27320 DIGITAL CENTRAL CONTROL UNIT FOR SULZER TW11

PARTS NEEDED FOR REPLACEMENT

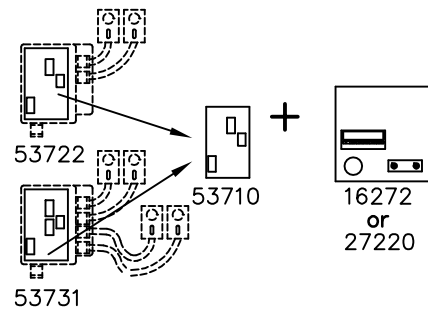
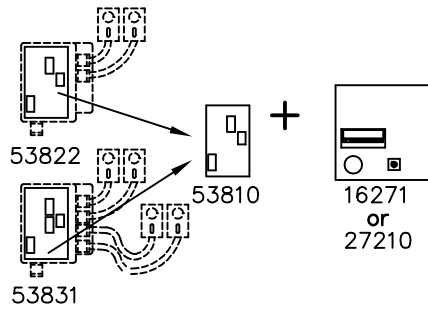
These central control units are no longer available as spare parts.

They can be replaced with a central control unit with digital function.

When replacement is made the amplifier box print has to be replaced as well.

Old parts to replace

New parts needed

PROJECTILE FINDER BOARD

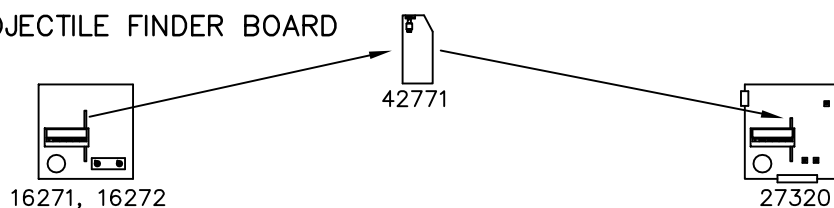
The projectile finder board 42771 on 16271 or 16272 can be moved and used on 27320.
